**CITY OF PORTSMOUTH, NEW HAMPSHIRE**

**ADDENDUM NO. 2**

**PEIRCE ISLAND FORCE MAIN AND WATER MAIN REPLACEMENT PROJECT**

**BID NO. 35-21**

SHEET 00 C-110 – PIPE PLAN AND PROFILE PEIRCE ISLAND BRIDGE  
SLIPLINING

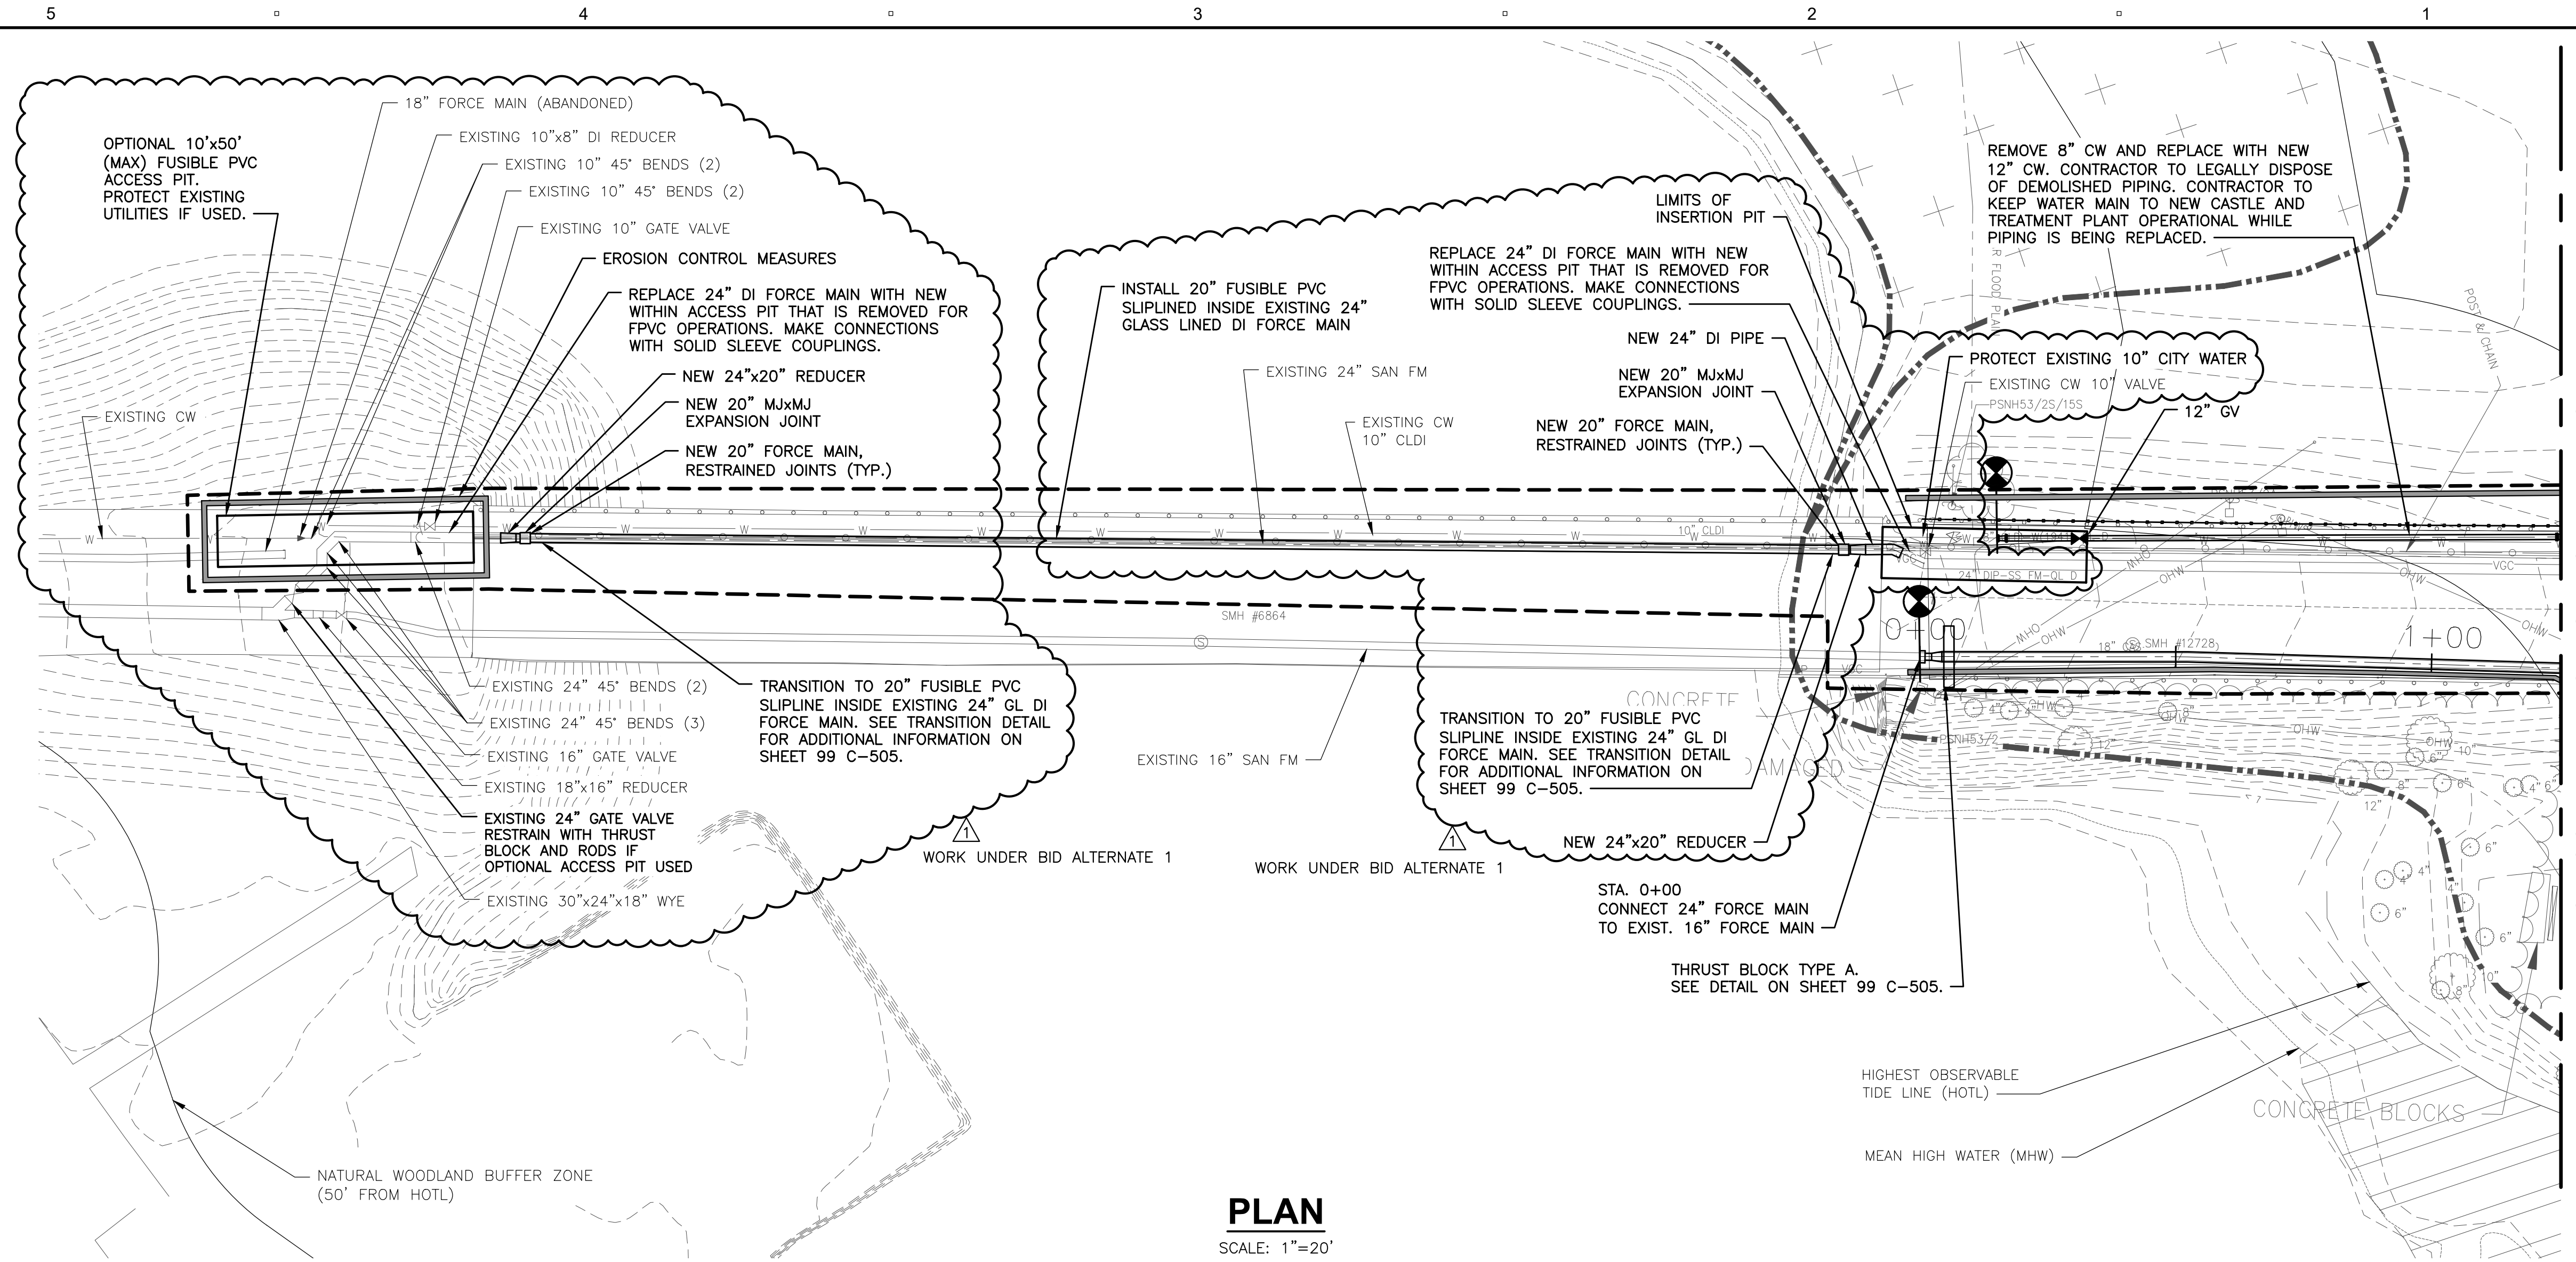
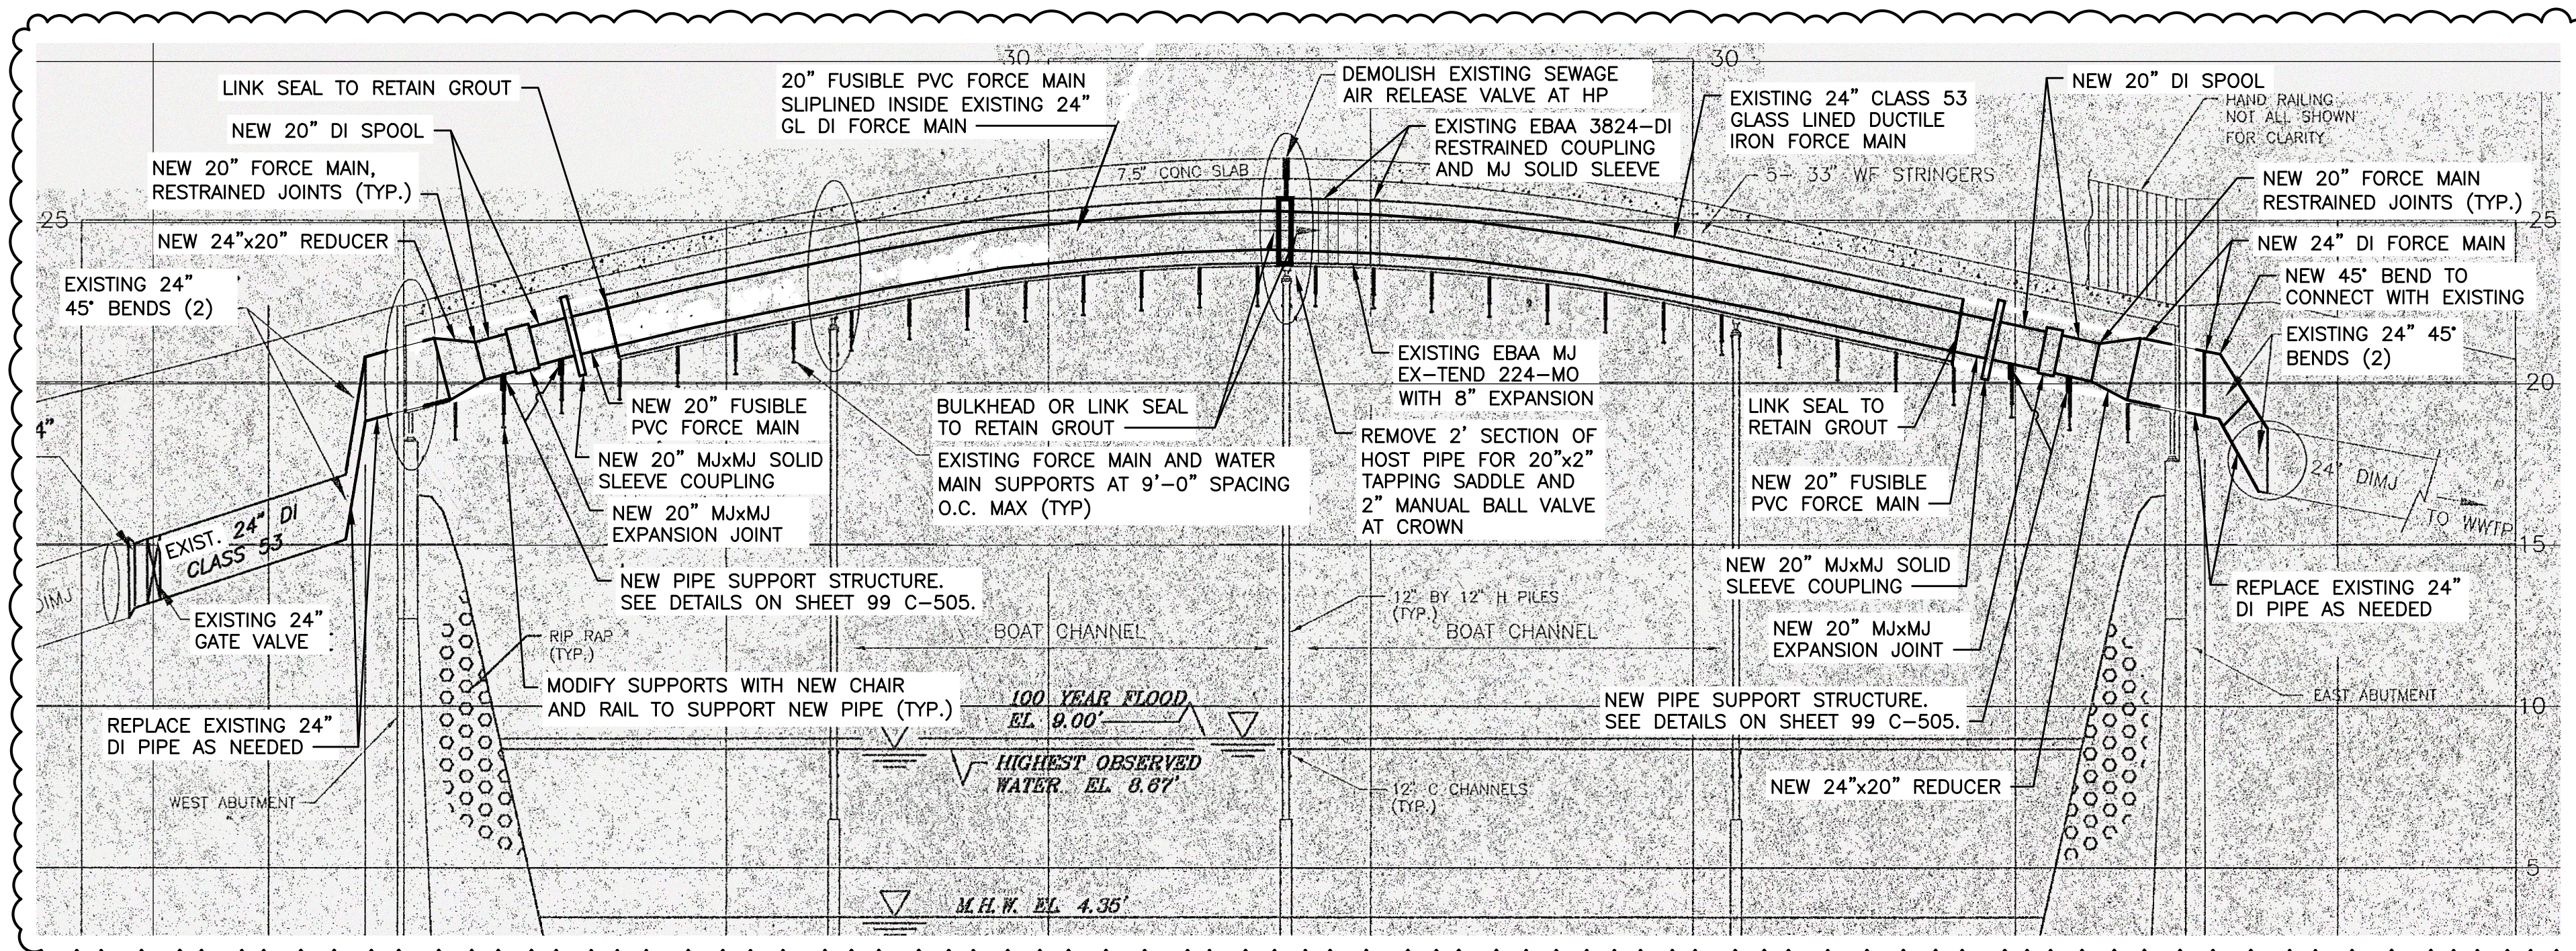
6. Sheet C-505/Pipe Support Detail: This is the only reference to pipe supports. Are we replacing pipe supports? What locations? I did not see a specification in the contract documents?

Answer: Refer to sheet 00 C-110 for locations of pipe supports.
